**Amendments to the Drawings**

### **Remarks/Arguments**

FIG. 6

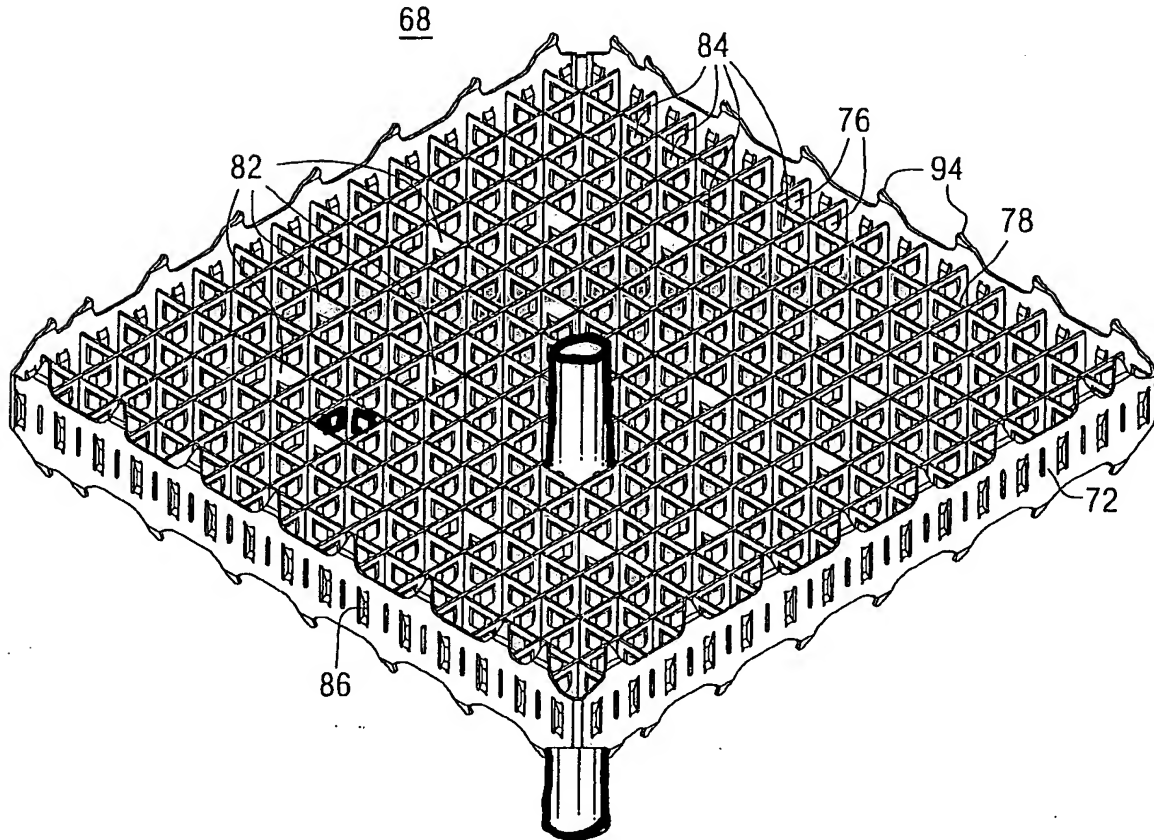
The attached sheet of drawings include changes to Figure 6. This sheet, which includes Figure 6, replaces the original sheet and any previous amendments including Figure 6. In Figure 6, the control rod guide tube and the welds that attached the control rod guide tube to the grid cell have been removed. Figure 6 has also been amended to better show that the springs in the grid cells that have springs, i.e., fuel rod support cells, are coplanar and are oriented in the vertical direction. Support for this clarification can be found on page 11, starting on line 5 and on page 11 starting on line 8.

Applicants' attorney respectfully disagrees with the Examiner's position. However, for the sake of advancing prosecution, applicants have further amended Figure 6 to clearly show that the dimples and/or springs are on the vertical and they are all within the same plane. Addressing the relative dimensions, the Examiner's attention is directed to Figure 5, which clearly shows the springs on a diagonal with the contact area shown relative to the width of the cell as being substantially less than that shown for the vertical springs and dimples shown in Figure 6 relative to the cell wall width illustrated in Figure 6. The Federal Circuit in *Hockerson-Halberstadt Inc. v. Avia Group International, Inc.* (222 F.3d 951,956, and 55 USPQ F.2d 1487,1491 Fed. Cir. 2000) stated: "It is well established that patent drawings do not define the precise proportions of the elements and may not be relied on to show particular sizes if the specification is completely silent on the issue." Thus, the court is acknowledging that the patent drawings do not have to show the precise proportions. Here, however, the specification does add to the drawings by clearly stating on page 11, starting at line 6, that the dimples and/or springs are co-planar, and on line 8, that the springs are on the vertical rather than on the diagonal. Starting at line 29, the specification specifically states: "The inner straps 76 and 78 on the auxiliary grids provide for a larger contact area between the dimple/springs and the fuel elements than are provided by the corresponding contact areas on the main support grids 46. The Court of Customs and Patent Appeals stated in *In re: Chitayat*, 408 F.2d 475, 161 USPQ 224 (CCPA 1969) that: Arguments based on mere measurement of patent drawings are of little value in absence of description in specification

In a telephone interview with the Examiner on April 27, Applicants' further agreed to amend Figure 6 to remove the control rod guide thimble and welds and delete Claim 13. With those changes the Examiner agreed that the changes to the drawings would be acceptable.

The Examiner asserted that the amendment filed 9/24/04 is objected to under 35 USC § 132 because it introduces new matter into the disclosure. The Examiner asserted that Figure 6 shows a 15 X 15 array, not a 17 X 17 array. Applicants fully agree. The earlier amendment was a typographical error. Figure 6 shows the 15 X 15 array and Figure 4 shows the 17 X 17 array. This further amendment has been made to the specification to correct this error.
